Work Order ID 110940

Item Name: Aft Crosstube - High

DRAWING NO. D412-664-243	TITLE CROSSTUBE ASS'Y (412 HI AFT)	REV. E	DART AEROSPACE LTD ENGINEERING ORDER		D.E.O. NO. D412-664-243-E-2	SHEET NO. SHEET 1 OF 1	SCALE NTS
DRAWN <i>MP</i>	CHECKED <i>ASS</i>	MFG. APPR. <i>E</i>	APPROVED <i>MP</i>		DE APPR. <i>MP</i>		
DATE 11.09.07	DATE 11.09.19	DATE 11.09.19	DATE 11.09.19		DATE 11.09.19

DRAWING NO. D412-664-243	TITLE CROSSTUBE ASSEMBLY (412 HI AFT)	REV. E	DART AEROSPACE LTD ENGINEERING ORDER		D.E.O. NO. D412-664-243-E-4	SHEET NO. SHEET 1 OF 3	SCALE NTS
DRAWN 92	CHECKED A	MFG. APPR. A	APPROVED MP		DE APPR. MP		
DATE 12.08.21	DATE 12.08.30	DATE 12.08.30	DATE 12/8/30		DATE 12.08-30

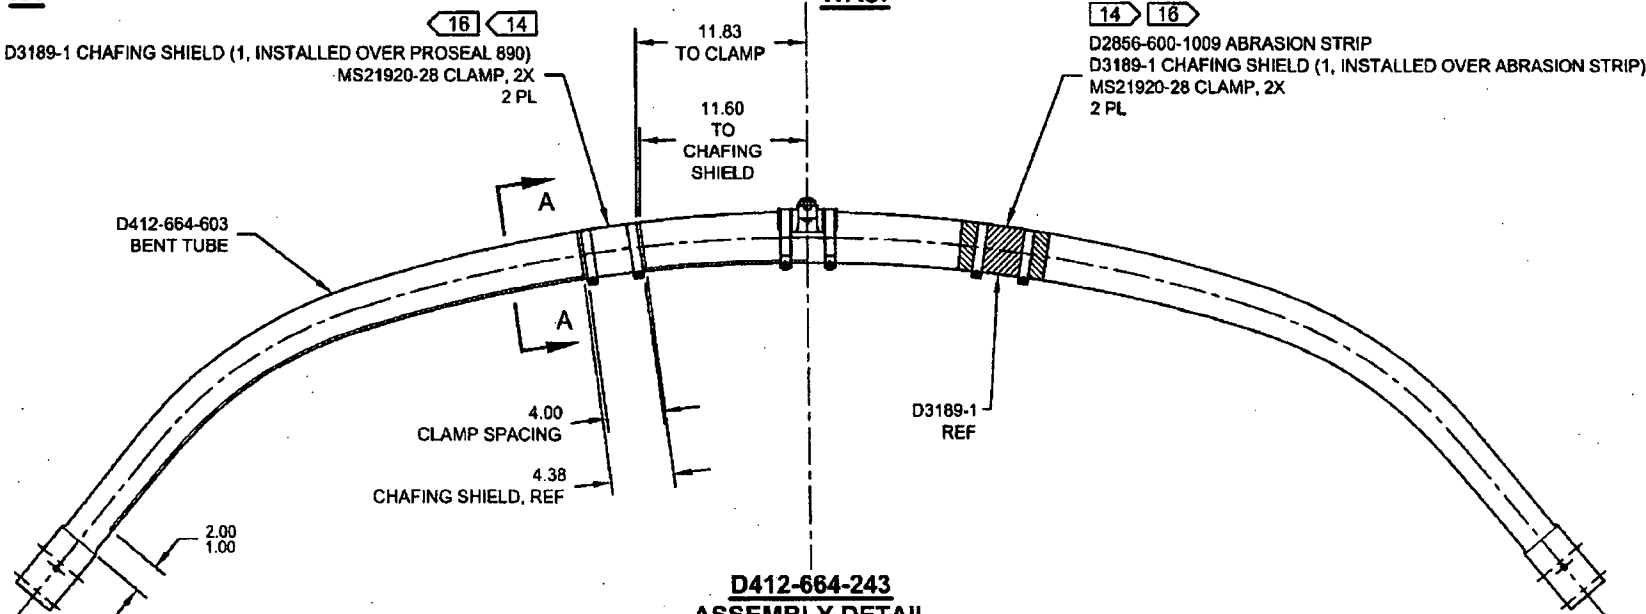
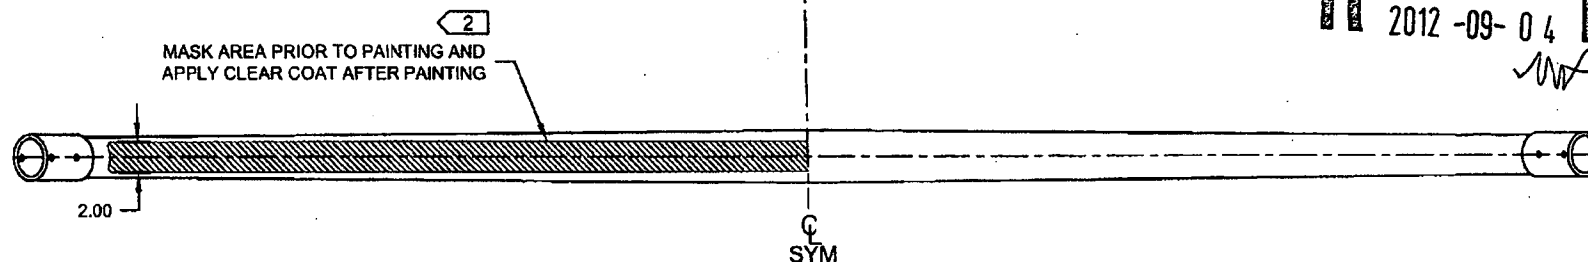
D3189-1 CHAFING SHIELD (1, INSTALLED OVER PROSEAL 890)
MS21920-28 CLAMP, 2X
2 PL

SECTION A-A
CHAFING SHIELD DETAIL
VIEW ROTATED, NOT TO SCALE

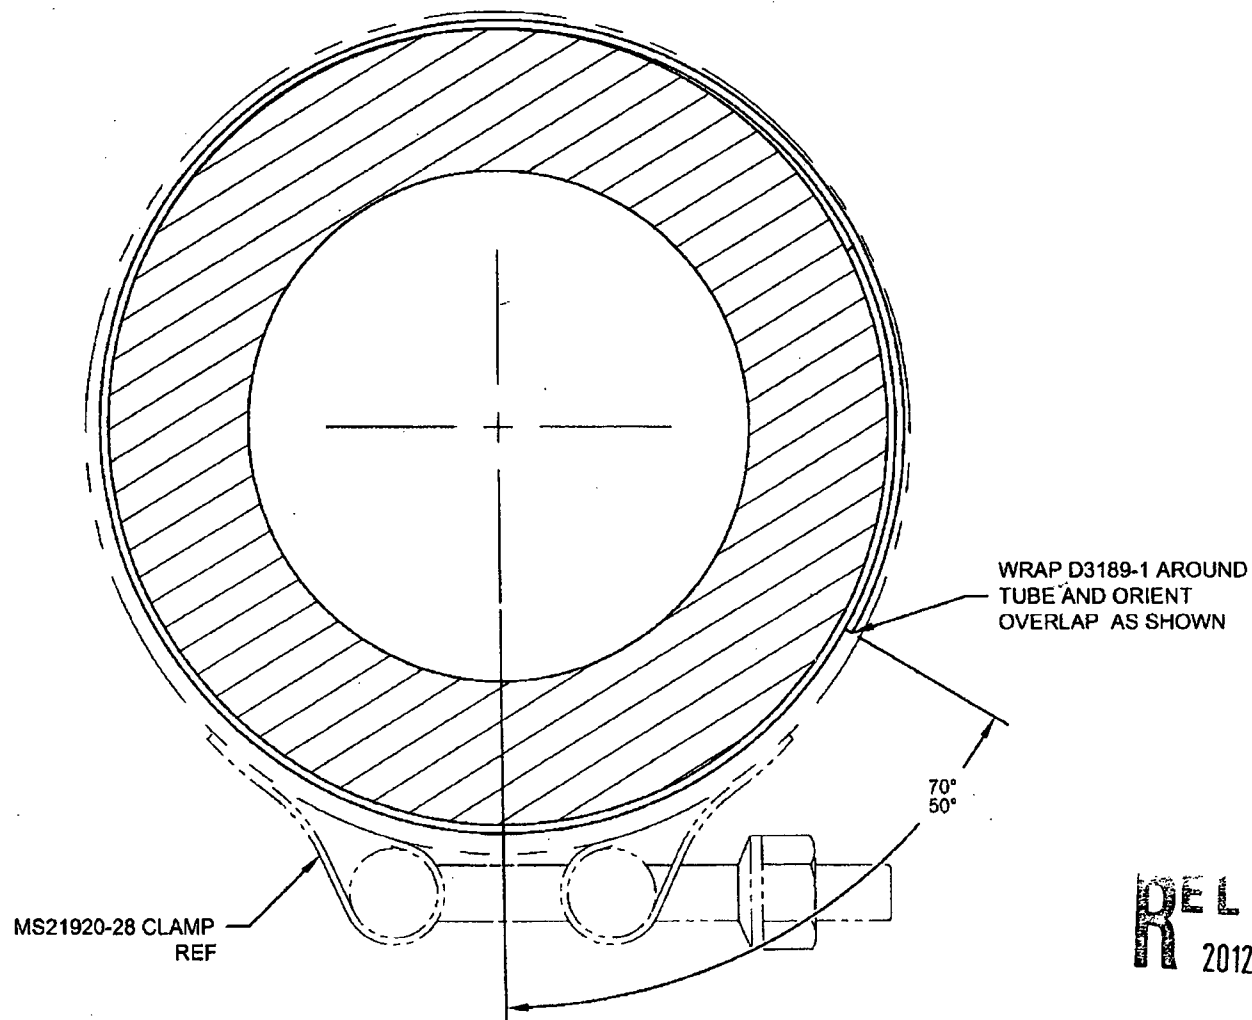
NOTES 2, 14, AND 16 ON SHEET 1 ARE AMENDED AS FOLLOWS:
